July 12, 1996

Docket No. 50-423  
B15803

Re.: IR 50-423/94-21

Millstone Nuclear Power Plant Station, Unit No. 3  
Pertinent Information Related to the Issue of  
Erosion of Cement from the  
Millstone Unit No. 3 Containment Mat

<b>Northeast Utilities System</b>			
FOR MILLSTONE NUCLEAR POWER STATION UNIT 3			
TITLE MEMBRANE & FOUNDATION MAT DETAIL			
BY <i>BIB/SL</i>	CHKD.	APP.	APP.
DATE <i>7-11-96</i>	DATE	DATE	DATE
SCALE <i>N.T.S.</i>	DWG. NO. <i>FIGURE I.1-11</i>		
P.A.*

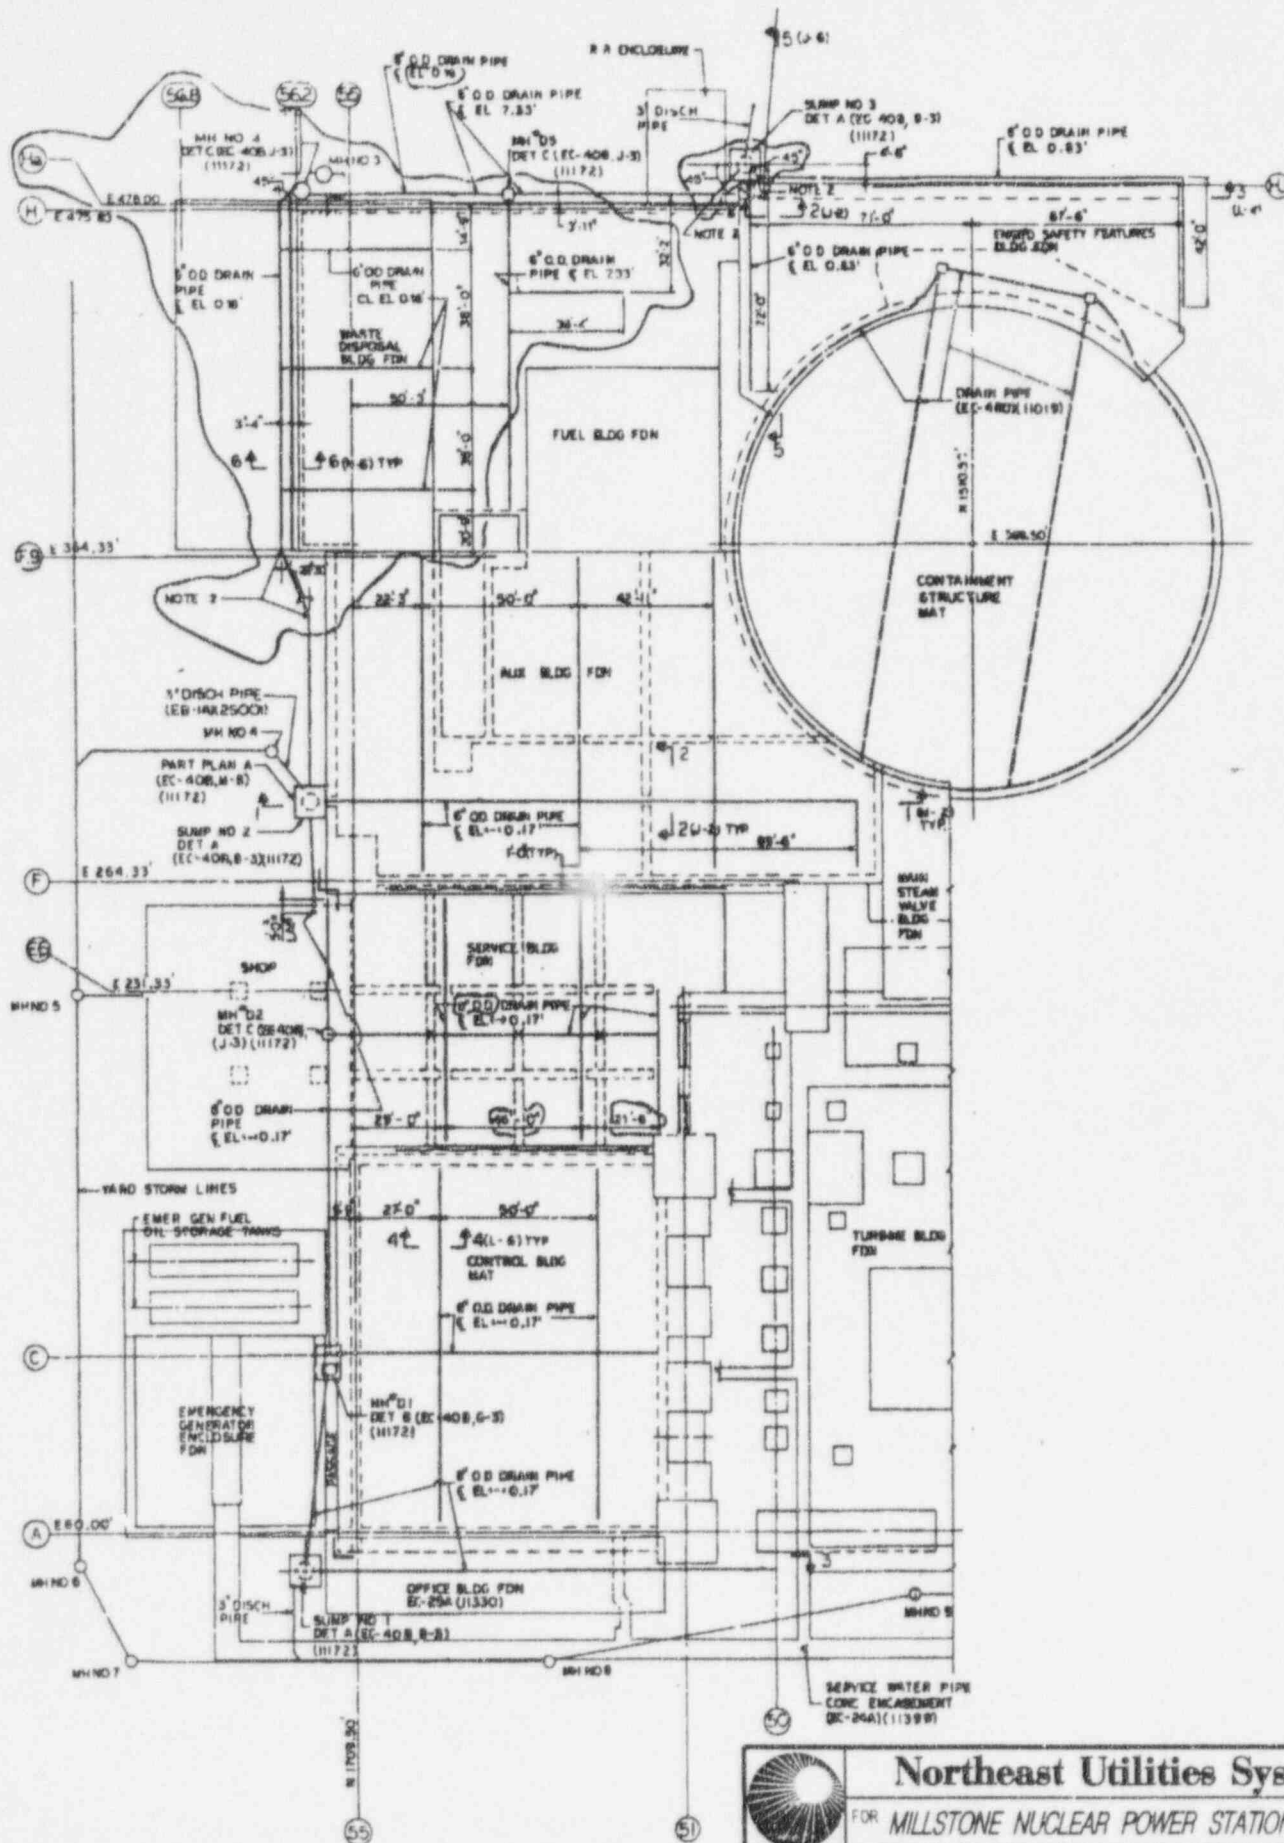
Provide sketches and description of the structure, materials of construction, sequence of construction.

A waterproofing membrane, consisting of a 1/16 inch thick butyl rubber, is placed below the containment mat and extends up the face of the containment wall to provide a watertight barrier between the Containment Structure and the 10 inch concrete layer in the foundation, and the containment and subgrade in the wall areas. Below the mat the membrane is placed on a layer of 10 inch thick porous concrete constructed with Portland Cement Type II, resting directly on the bedrock. Above the membrane, a 2 inch thick layer of protective concrete is placed with an additional 9 inch thick layer of calcium aluminate porous concrete on top. The 10 foot thick reinforced concrete mat is placed on top of the 9 inch layer constructed of calcium aluminate porous concrete. The membrane along the face of the containment wall is sandwiched between two 2 inch thick layers of compressible material as indicated on Figure I.1-11.

FIGURE 3.7B-9  
DYNAMIC MODEL OF  
THE CONTAINMENT STRUCTURE  
MILLSTONE NUCLEAR POWER STATION  
UNIT 3  
FINAL SAFETY ANALYSIS REPORT

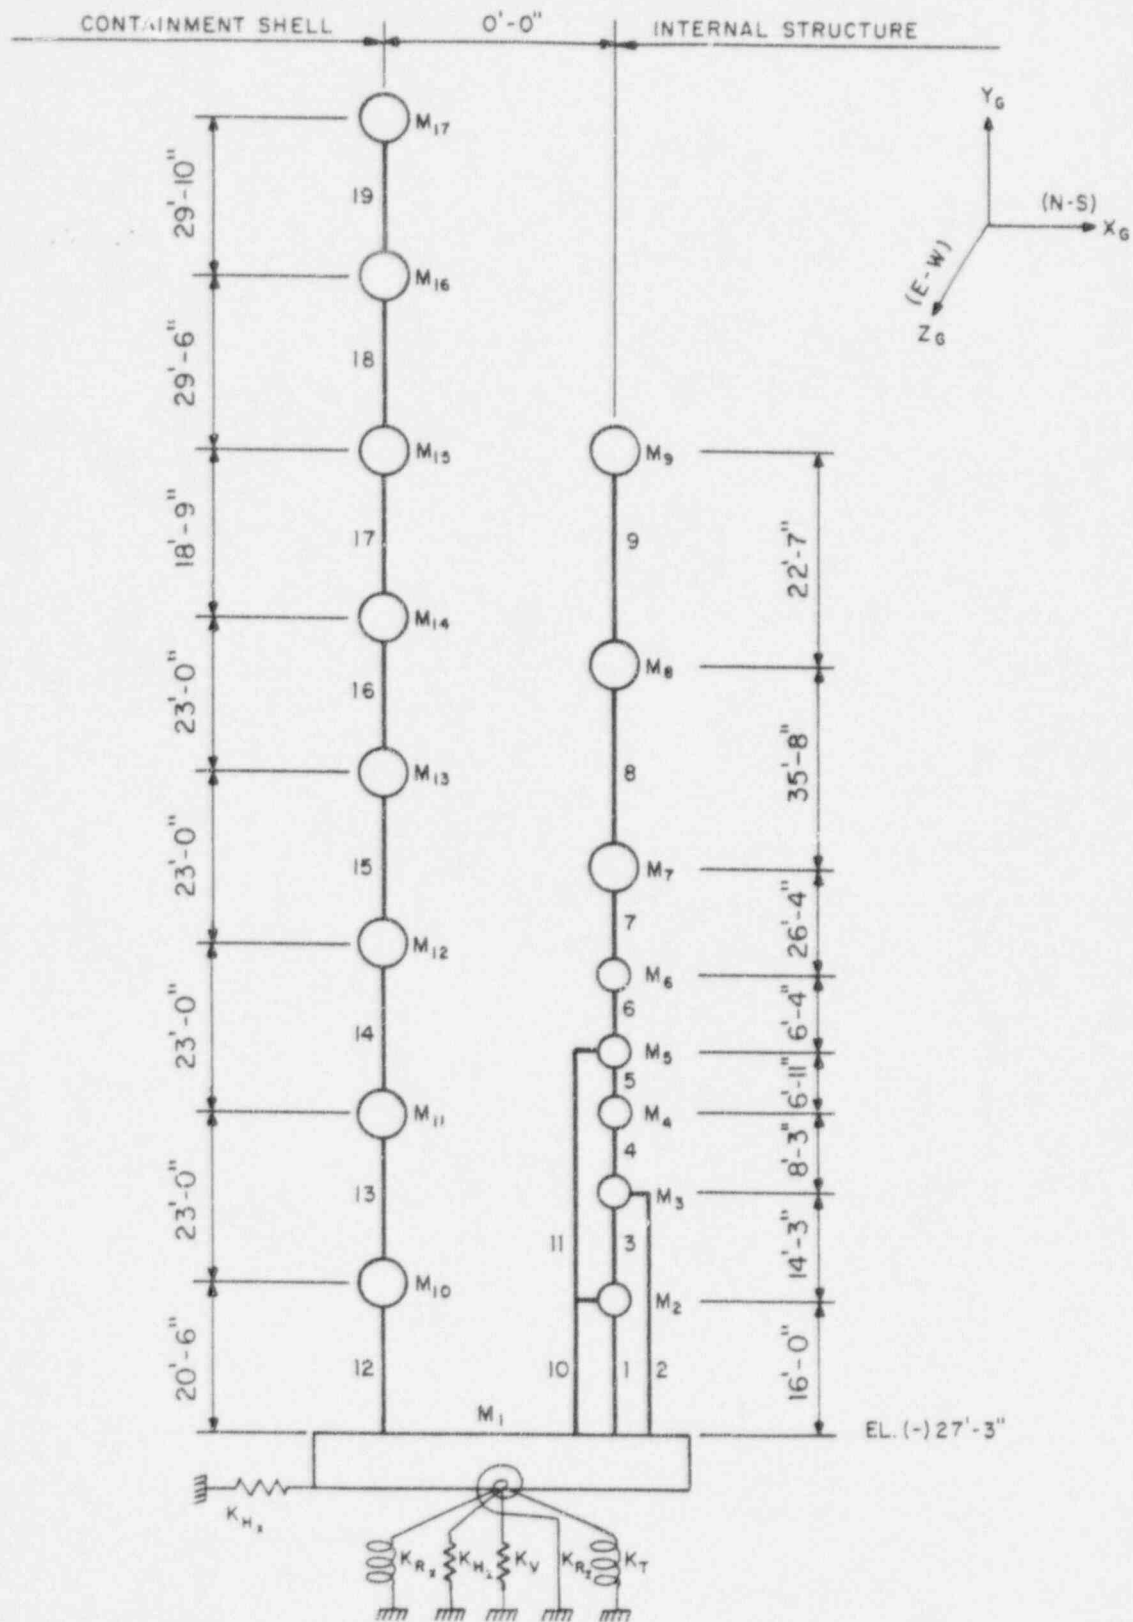
How were the spring constants determined to represent the rock, shown in FSAR Figure 3.7B-9, used in the dynamic model of the Containment Structure.

The stiffness of the horizontal, vertical, rocking and torsional subgrade springs have been calculated based on the assumption of a rigid circular plate resting on a semi infinite depth of subgrade material. The stiffness values corresponding to attached FSAR Figure 3.7B-9, are as follows:

The rock properties and the equations used to calculate the spring constants are included in Figure VII.1-1. These constants have been extracted from calculation 12179-NS(B)-025.
